# TECHNICAL MEMORANDUM 1

## REVISIONS TO FINAL

## PHASE I RFI/RI WORK PLAN

# WALNUT CREEK PRIORITY DRAINAGE (Operable Unit No. 6)

FIGURE 7-5

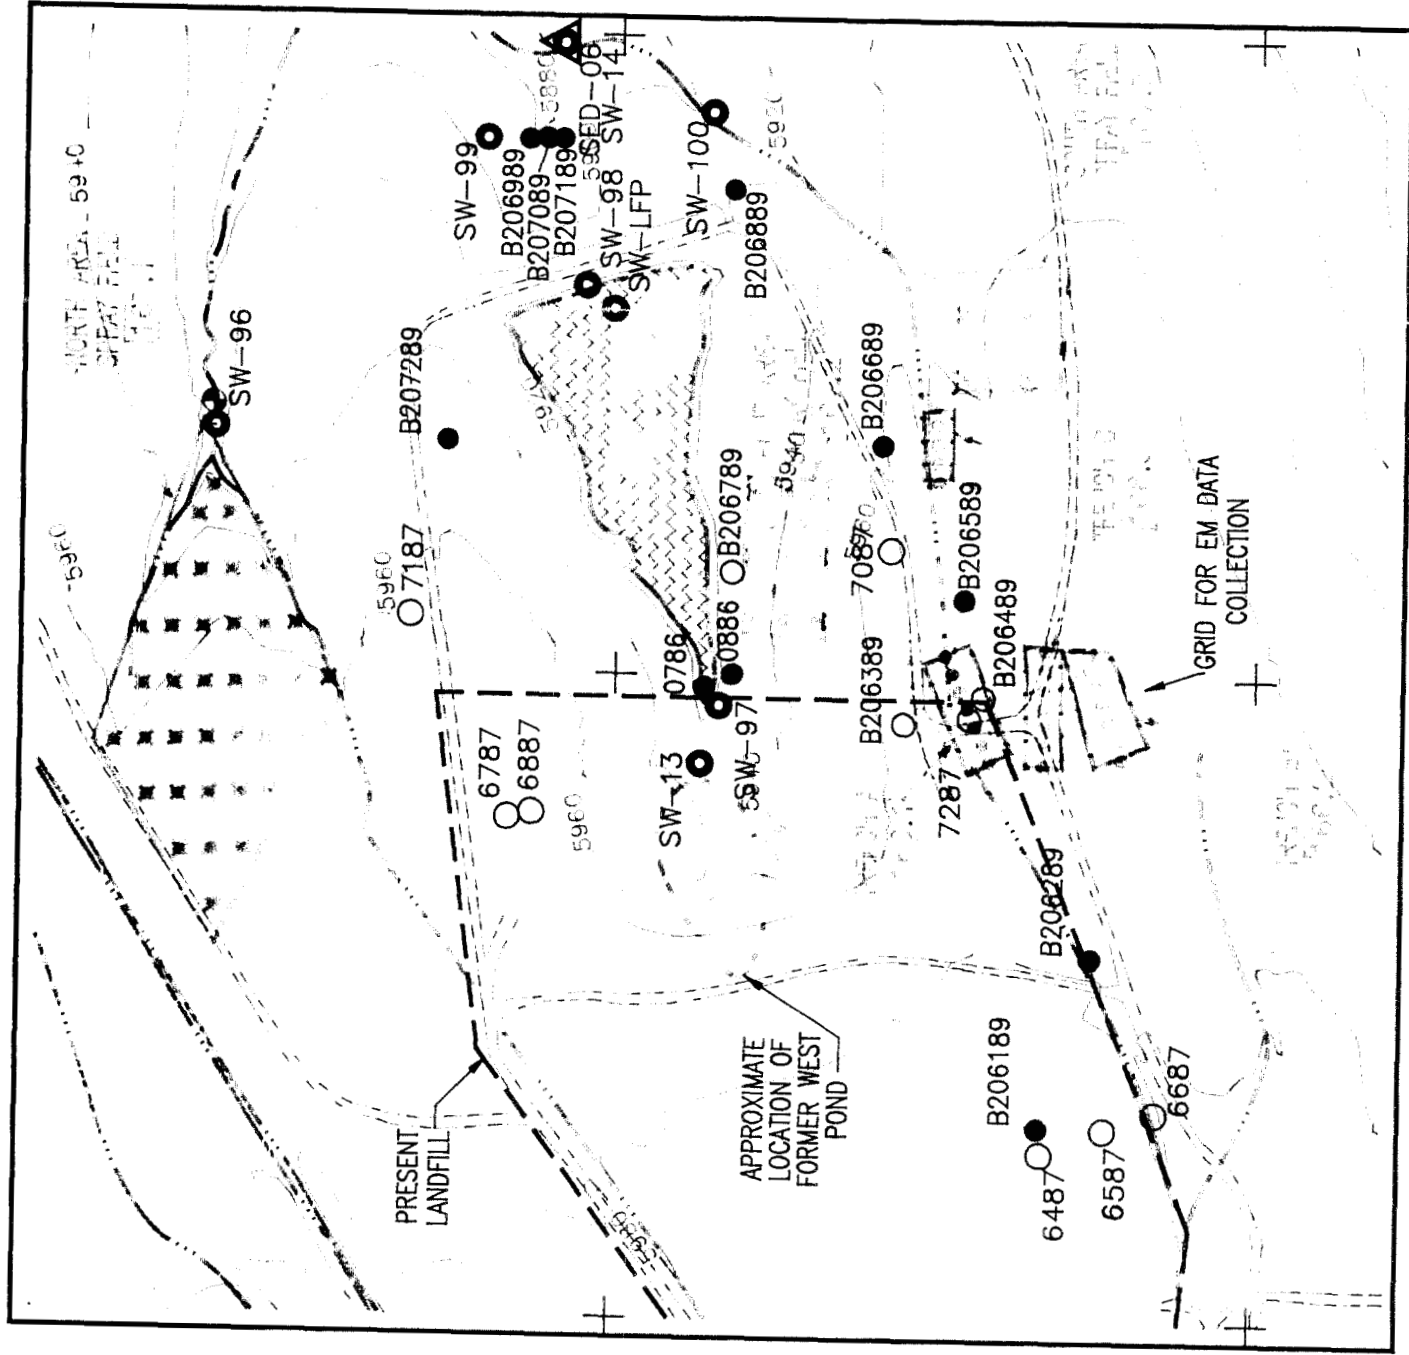
Step 3 will provide data from the pre-existing surface; however, the location of the boreholes as depicted on Figure 7-5 are misleading. A review of Figure 2-14 clearly shows that proposed boreholes along the east boundary (and others) will not target suspected areas of contamination. Figure 2-14, therefore, should be used as a base to select borehole locations, not Figure 7-5.

Response to C-108: This concern is addressed in Section 7.2.3 text revisions and revisions to Table 7-4. DOE concurs that the location of the boreholes as depicted on Figure 7-5 are inaccurate. Figure 7-5 has been revised to incorporate the details shown on Figure 2-14 so that the borehole locations will target suspected areas of contamination.
